RE: Development of Regional Impact Review (DRI) - *Notification Only*

Name of Proposal: Roswell Exchange

ROSWELL EXCHANGE DRI City of Roswell Natural Resources Division Review Comments

CONCEPTUAL SITE PLAN

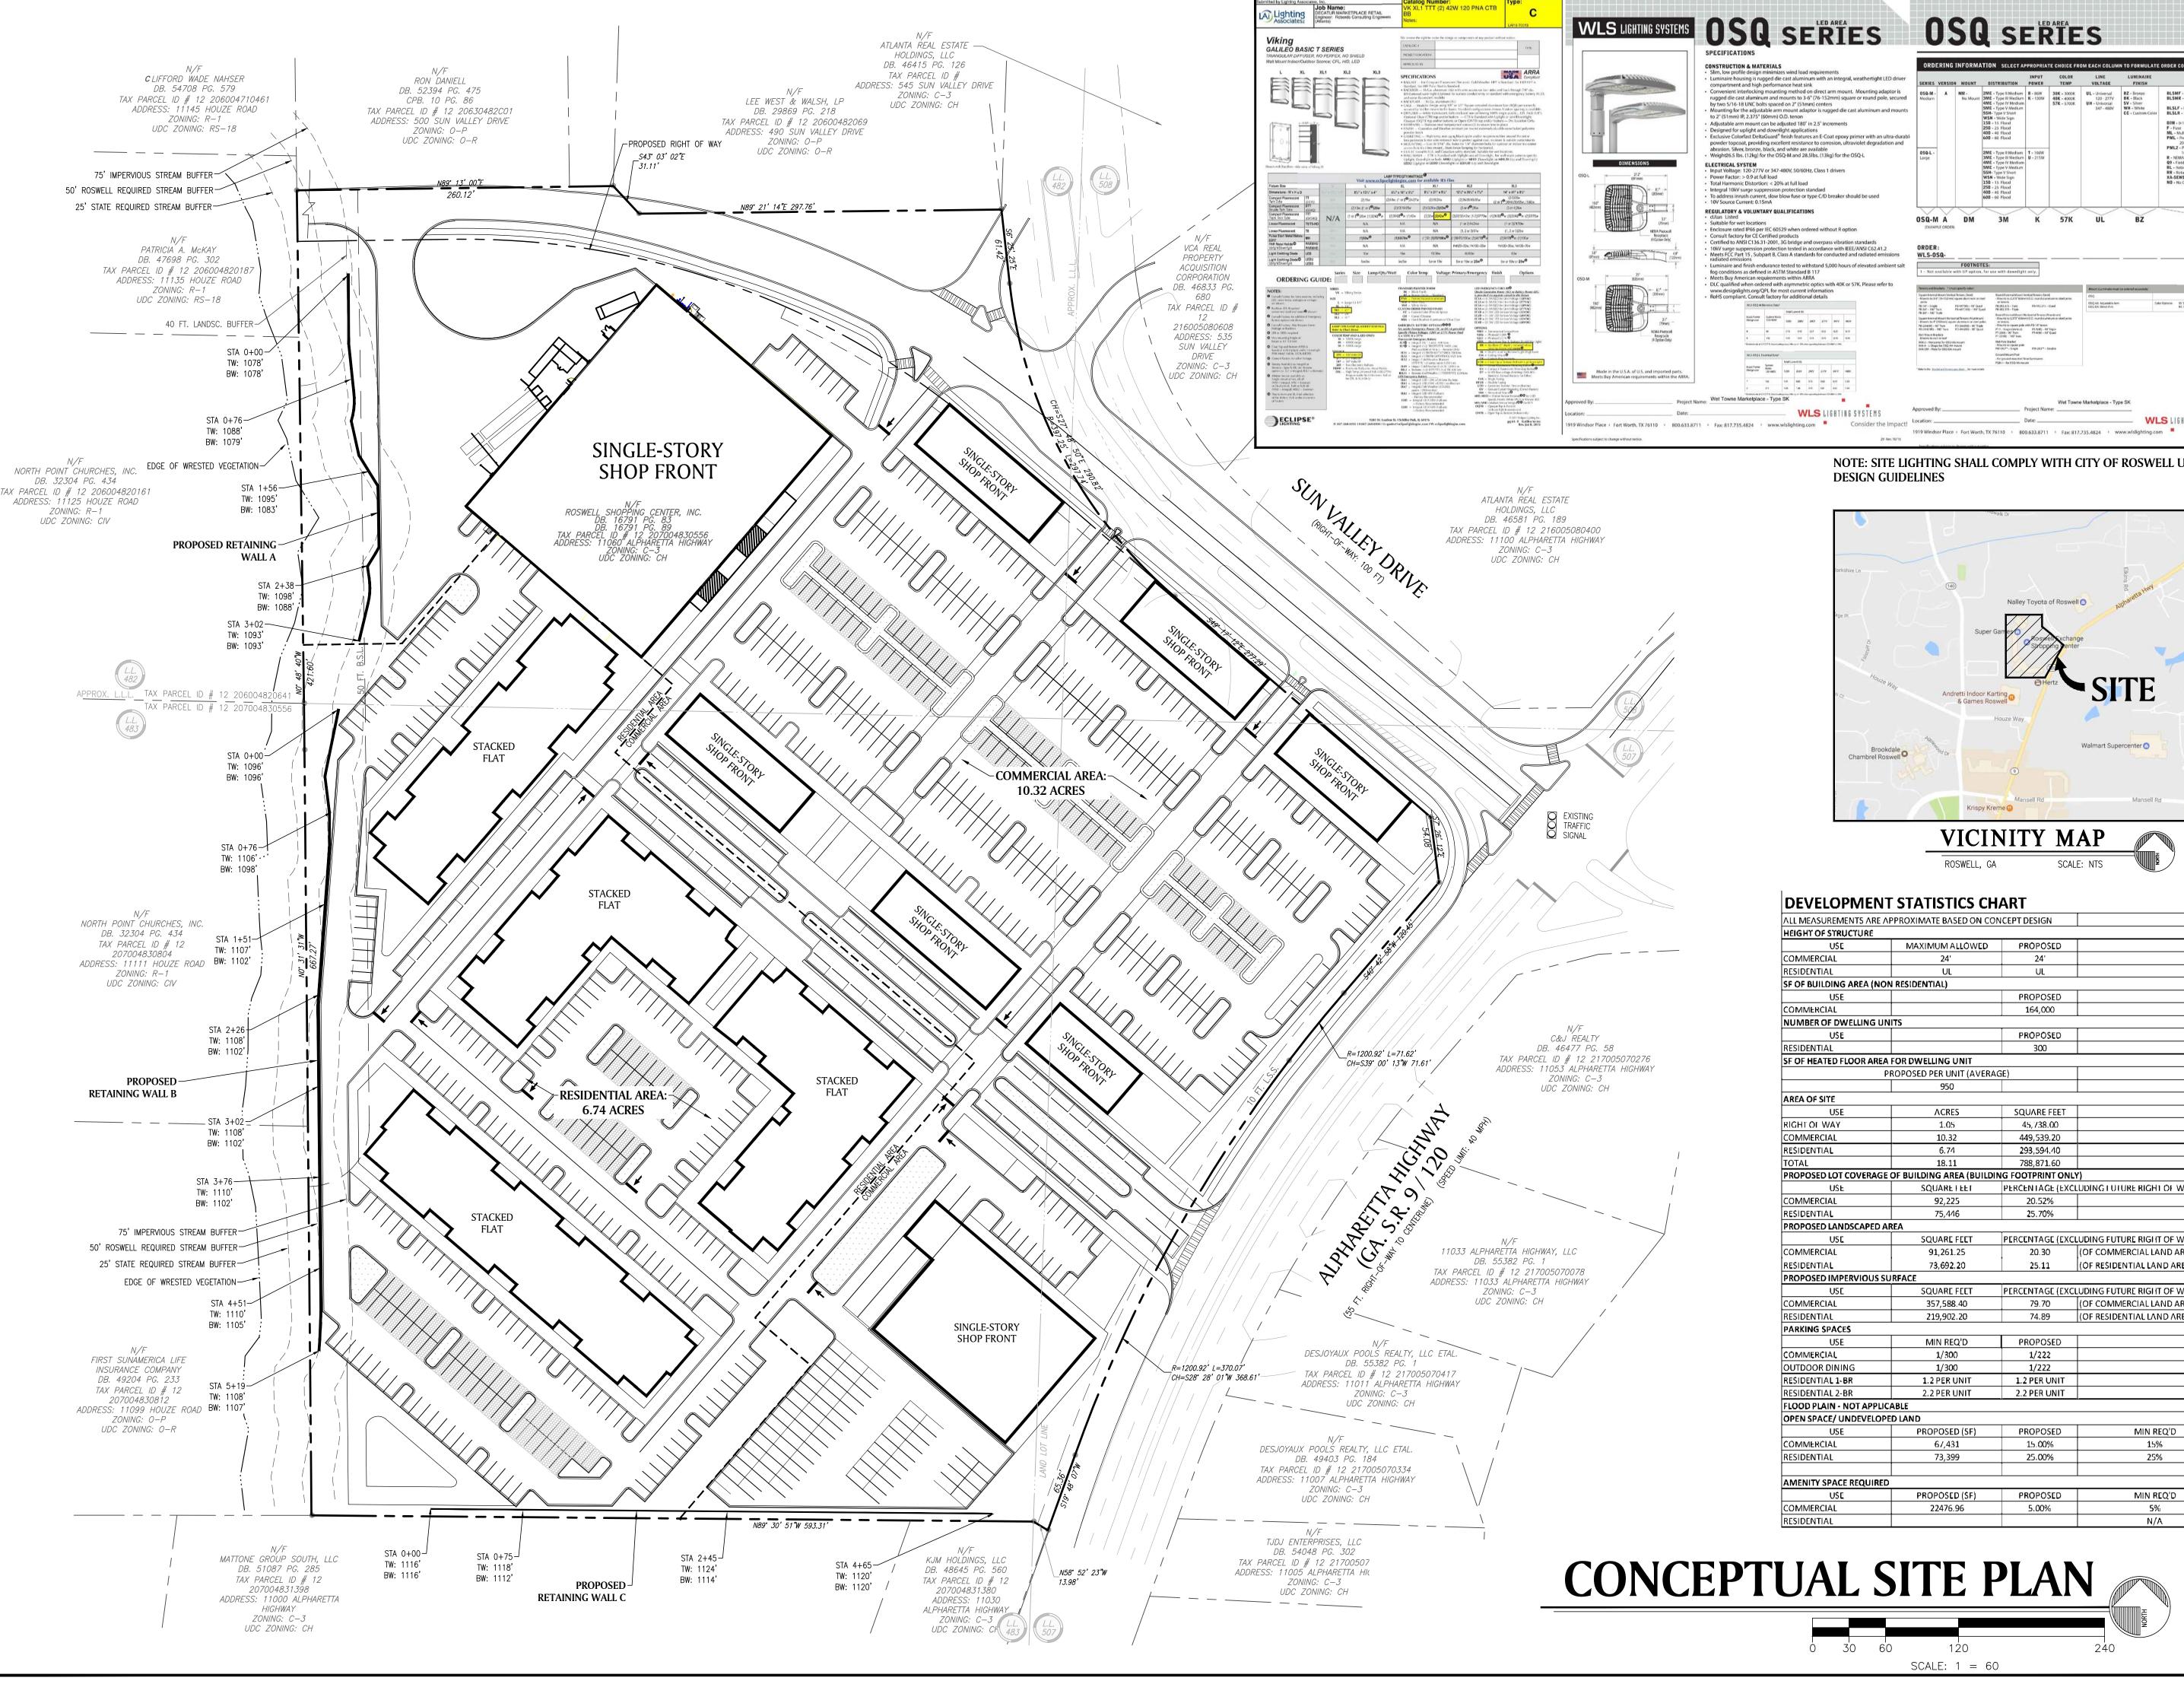
The USGS coverage for the project area shows no blue-line streams on or near the project property. However, the submitted site plan does show stream along the western boundary of the property. The site plan also shows the City's 50-feet vegetative buffer and the additional 25-foot (total of 75 feet deep) impervious surface setback. The 25-foot State sediment and Erosion Control buffer is also shown. However, the site plan also shows retaining walls and an access road intruding on the City buffer or setback. Aerial photo evidence indicates that there appears to be little intrusion by the existing shopping center into either the buffer or the setback. Such intrusions may require a variance from the City of Roswell. Any other waters of the State on this property will be subject to the State 25-foot Sediment and Erosion Control buffer.
